Technical Newsletter

This Newsletter No. SN31-6270

IBM 5114 Diskette Unit Maintenance Information Manual

Summary of Amendments

Diskette Control Card

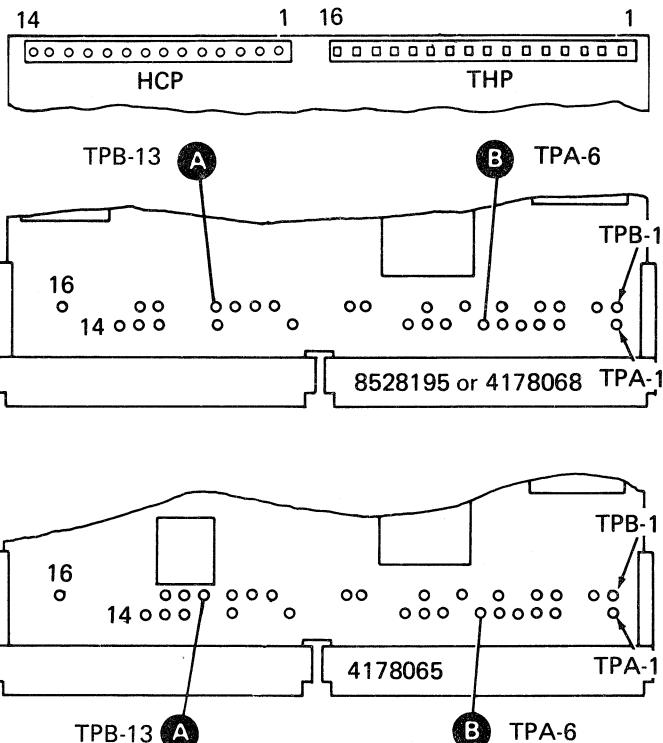
Correct an error on the diskette control card drawing.
